3. 802 Ocean Avenue

3.I. Memo

Documents: [PB MEMO -OCEAN AVE -802-10.27.15.PDF](#)

SHEET 5 OF 14

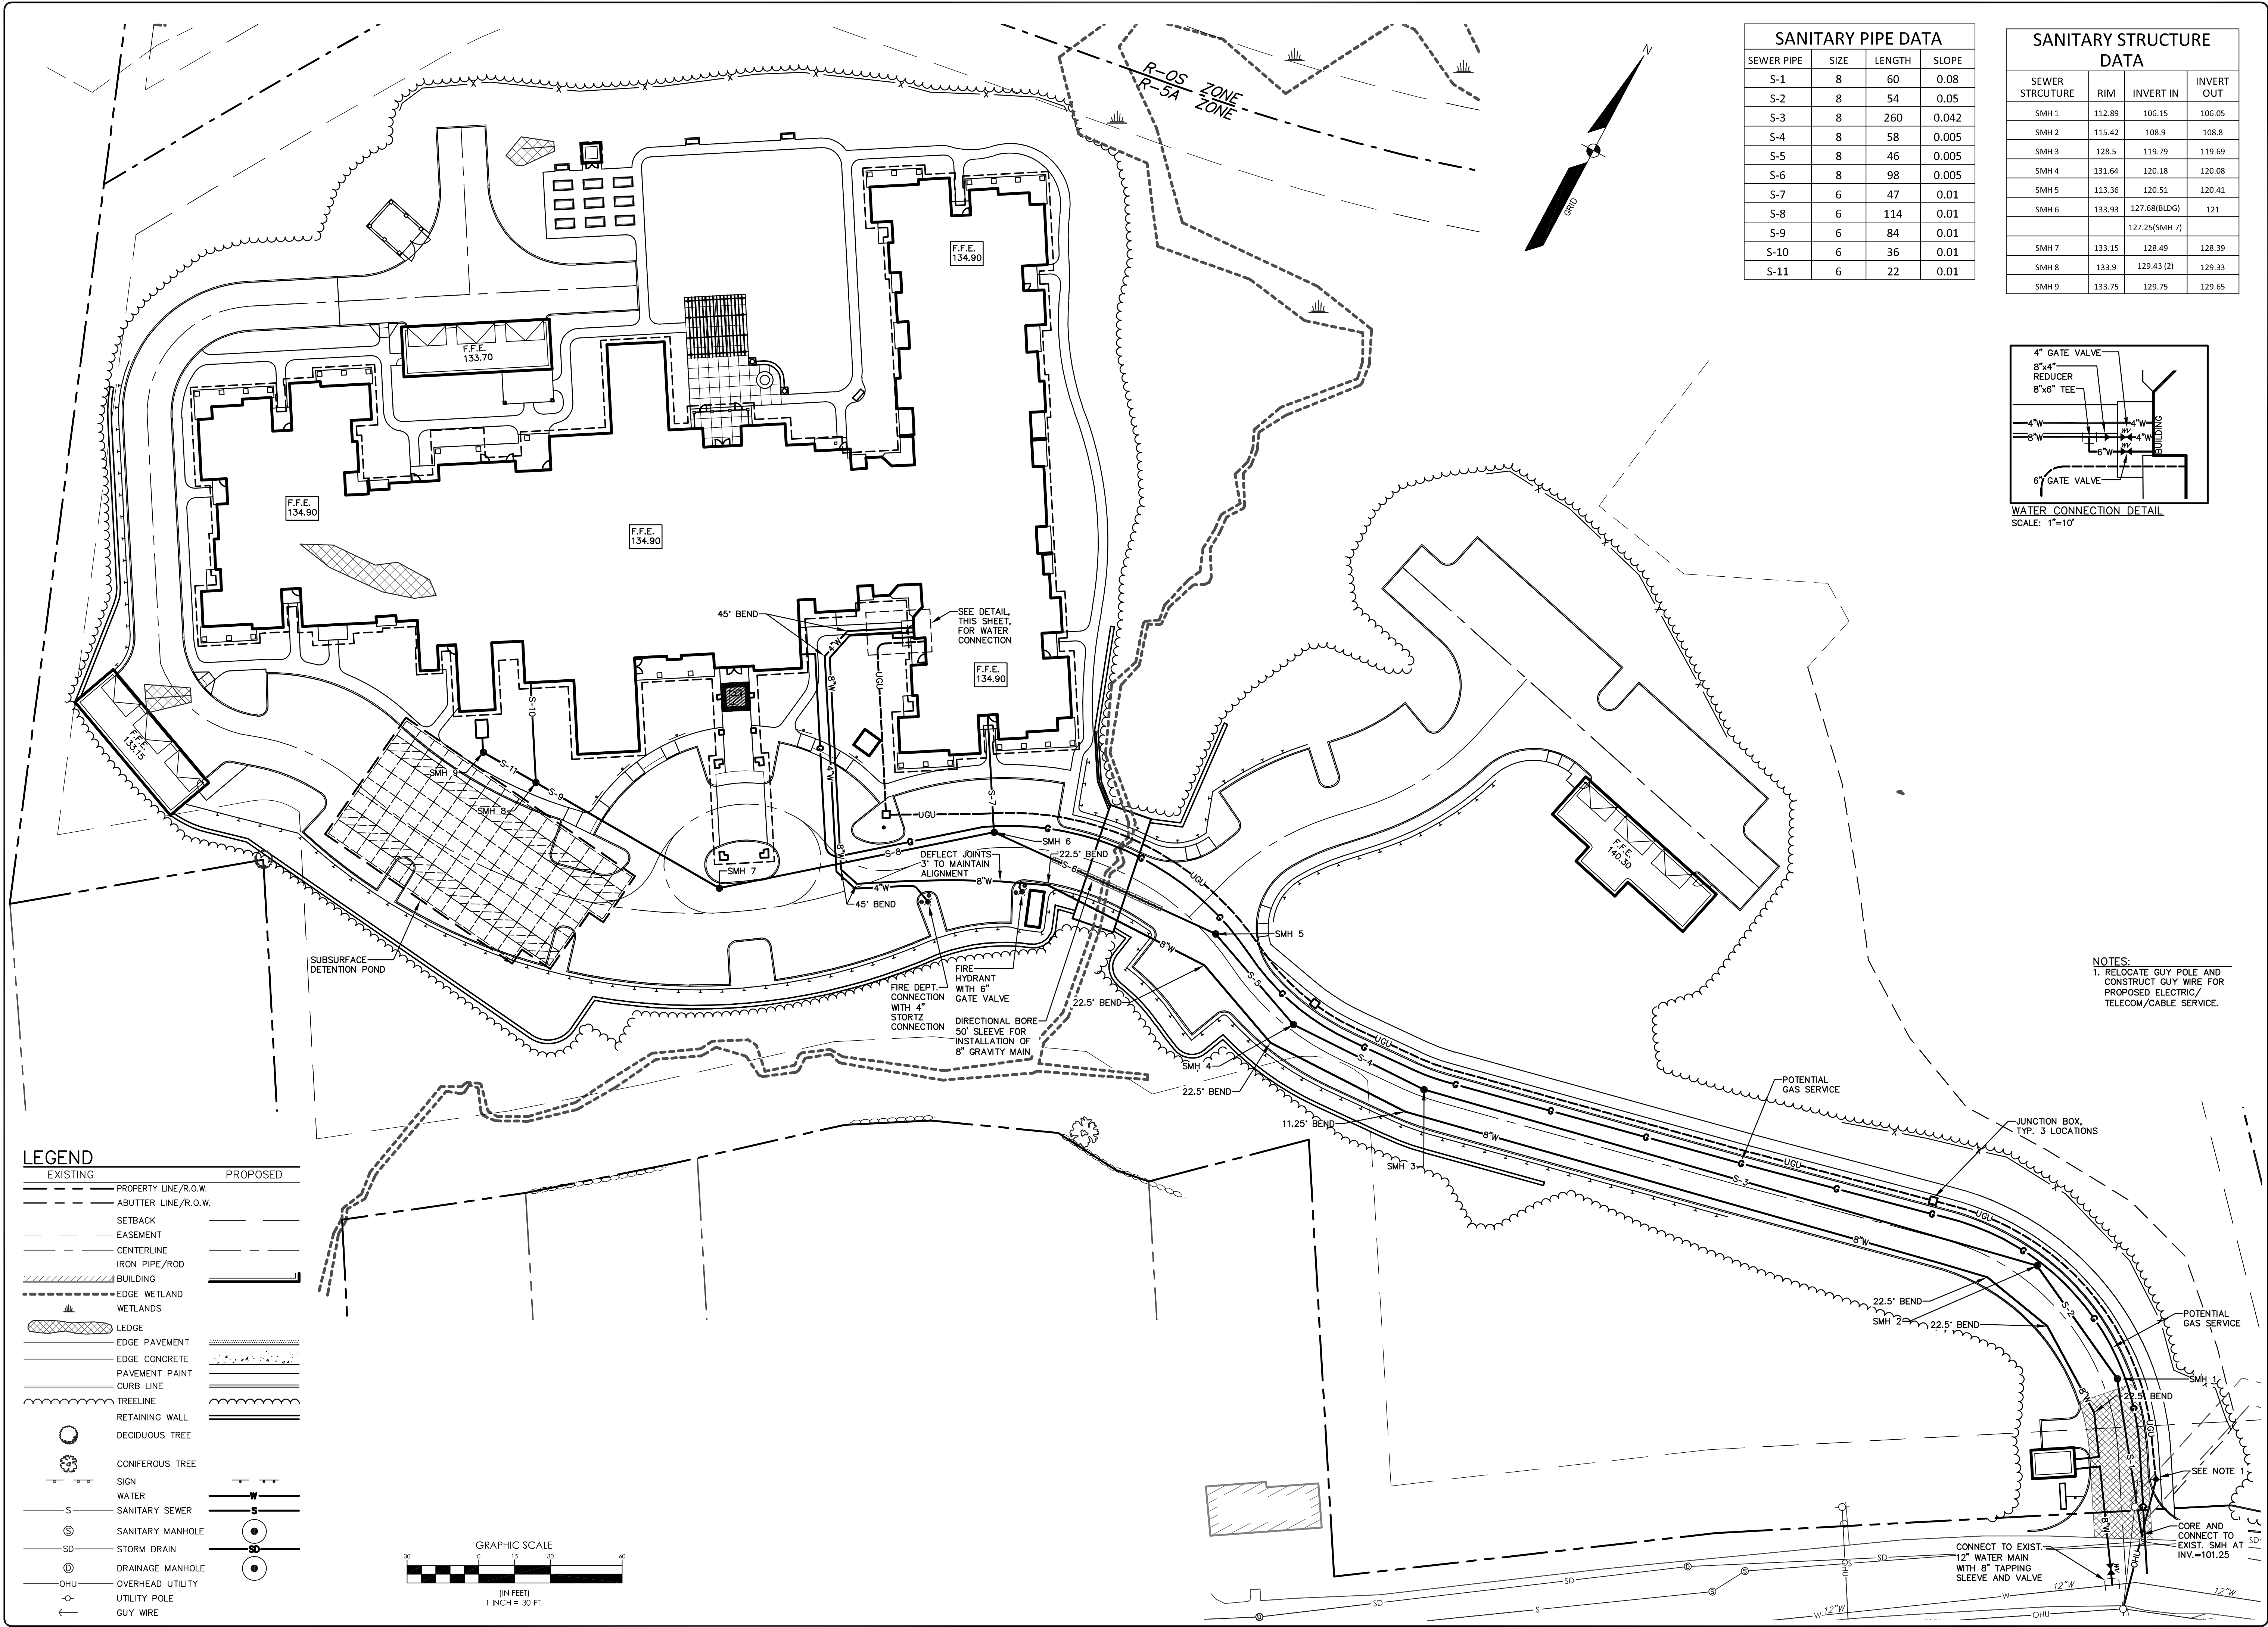
- iii. Sheet 6 of 14 – Discharge pipe SD 17 from CB-7 and the Underdrained Soil Filter discharge to a level spreader that, based on the downhill topography, could result in additional flow running onto a neighboring property. This outlet pipe and level spreader should be repositioned to the east of the currently proposed location such that flow below the discharge will remain on the project property prior to entering into the ROW.

system discharging into the drainage channels. The discharge from the foundation drain system should be factored into the stormwater model. Also, the foundation drain outlet depicted on Sheet 6 of 14 may be in conflict with the corner of the subsurface sand filter system; the Applicant should verify.

- 7) The Grading and Drainage Plan should be revised to indicate the location of the spillway for the Underdrained Soil Filter.
- 8) Sheet 6 of 14 – A drain manhole should be provided for the 12” storm drain connection into the 18” storm drain in Ocean Ave. The storm drain pipe material should be identified to meet City Standards within the roadway right-of-way (Technical Manual Section 2.5.2).
